**Amendments to the Code of Practice for
the Mandatory Building Inspection Scheme and the Mandatory Window Inspection Scheme 2012
30 April 2018**

Procedural Requirements for MWIS

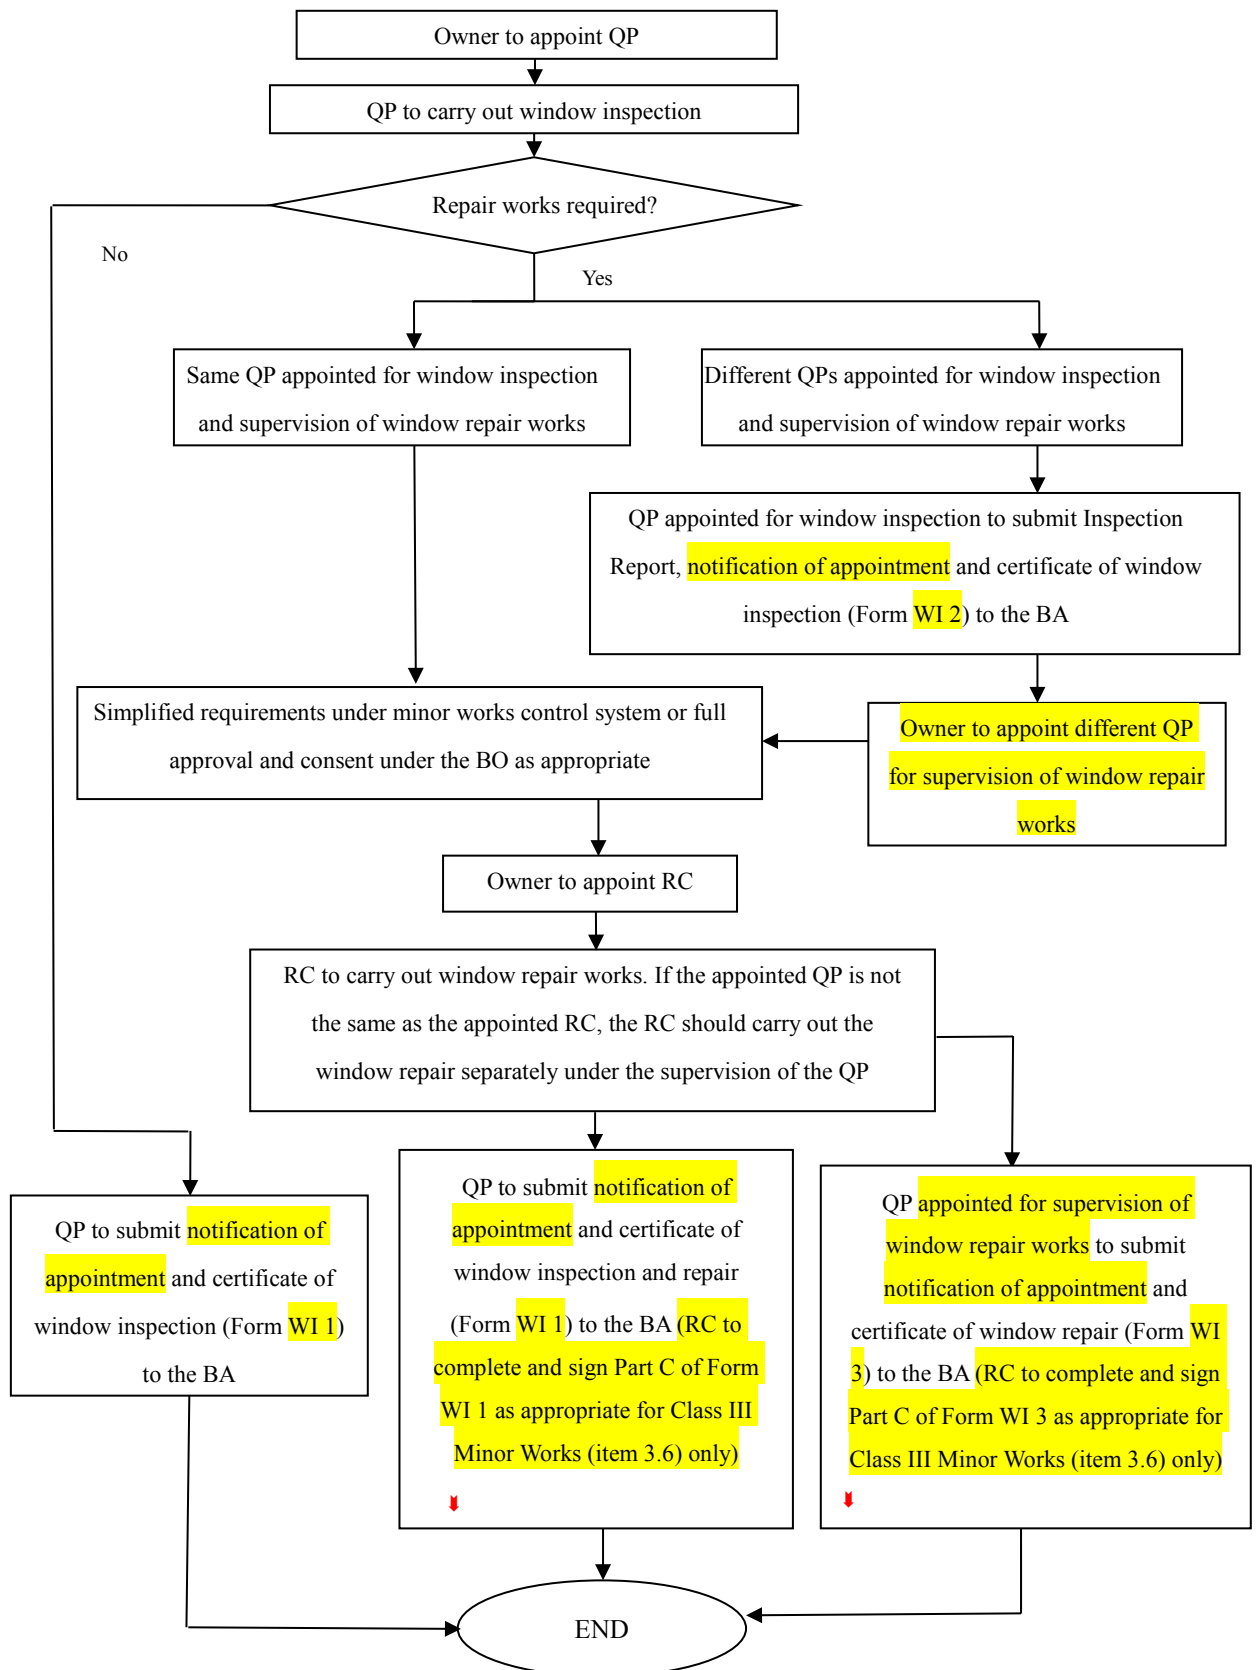
5	Appendix IX	Flow chart for procedural requirements for MWIS	Revised flow chart in page 6 of this Annex	■ To incorporate the amendments in item 3 above.
6	Appendix X	Tables for Specified Forms for MBIS and MWIS	Revised tables in pages 7 and 8 of this Annex	■ To incorporate the amendments in item 3 above.
